Access Compliance Report Public Rights-of-Way (Pedestrian Signals)

Main Street: **DANA_POINT_HARBOR_DR** Cross Street: **STREET_OF_THE_GOLDEN_LANTERN** Location: **NE**

ADA ID: **SGRK220208164210** Signal Type: **One Push Button-Non APS** Overall Compliance: **No** Severity Scores: **BTN 1: 25** **BTN 2: N/A** **No BTN: N/A**

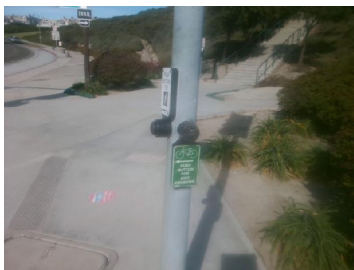
Surveyor Notes: Button 2 for Bike Lane

OC Std/PROW: R404.2, R404.3

Possible Solutions: Remove and Replace Clear Space.
